Thorndon Quay Cycleway Safe System Audit Report

Safe System Audit Post Construction

Client: Wellington City Council

Job No.: 60681824

Figure 5. Sign and streetlight at bus stop

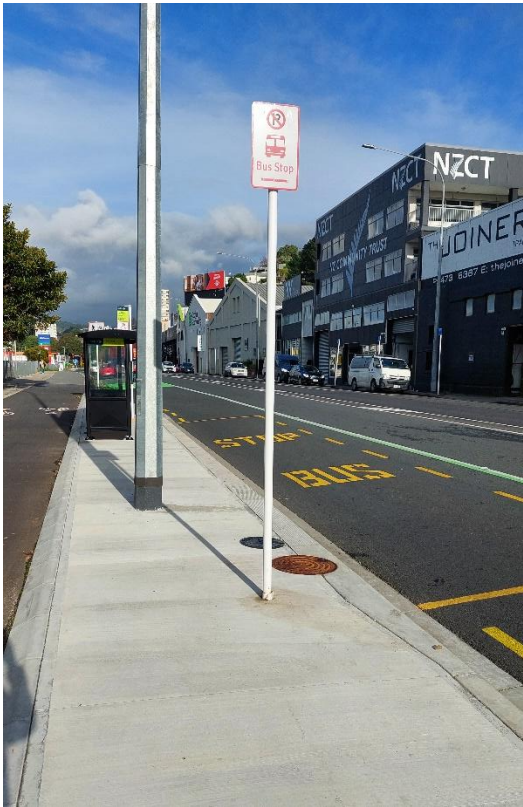
The bus stop on the city bound side of Hutt Road at Omega Car Rentals has a streetlight column and a bus stop sign located in the bus stop island. The SSAT are unsure that someone in a wheelchair would be able to manoeuvre around the sign and light column to get to the bus stop. With the bus stop sitting on a raised island this creates a risk that the wheelchair user would fall off the island as they attempt to manoeuvre through the gap which could result in serious injuries.

Review the position of the street light column and bus stop sign to confirm wheelchair users can access the bus stop.

Probability Rating:		Severity Outcome Rating:	
Crashes are likely to be	Unlikely	Death or serious injury is	Serious
Design Team Response: To be reviewed.			
Safety Engineer:		Comment pending Design Team response.	
Client Decision:		Comment pending design team response.	
Action Taken:		Pole location to be reviewed by Designer and recommendation to resolve the issue.
